**STAFF REPORT
FOR THE HISTORIC REVIEW BOARD**

FILE NUMBER: DR-22-03/MISC-22-03/WRG-22-02

HEARING DATE: June 21, 2022

REQUEST: Class II Historic Design Review, Non-Conforming Review, and Willamette River Greenway Permit for the adaptive re-use of Old City Hall for office and cultural center use by the Willamette Falls and Landings Heritage Coalition.

SITE PLAN 1" = 20'

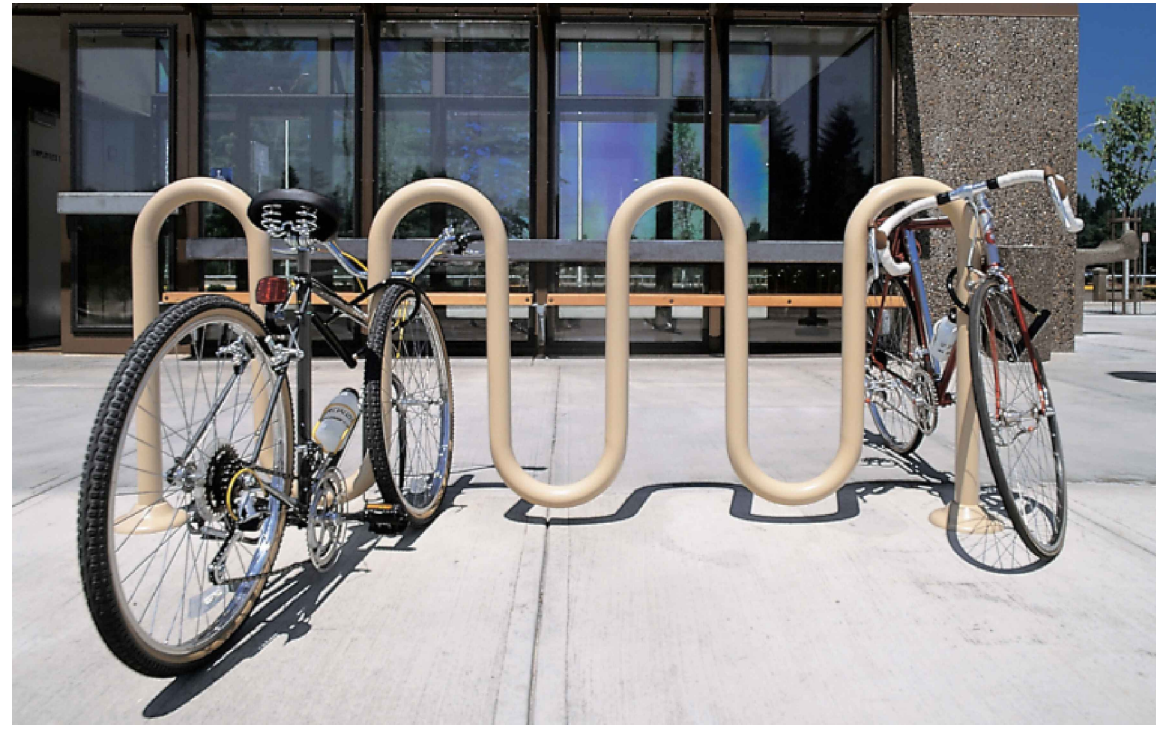
Staff Finding 24: As demonstrated on the site plan contained in HRB-1, parking is provided within 200 feet of the entranceway, with carpool and ADA accessible parking spaces immediately adjacent to the building. Subject to approval by the Historic Review Board, this standard is met.

Staff Finding 28: The proposed site plan in HRB-01 indicates includes three parking spaces adjacent to the western entrance as carpool spaces. This standard is met.
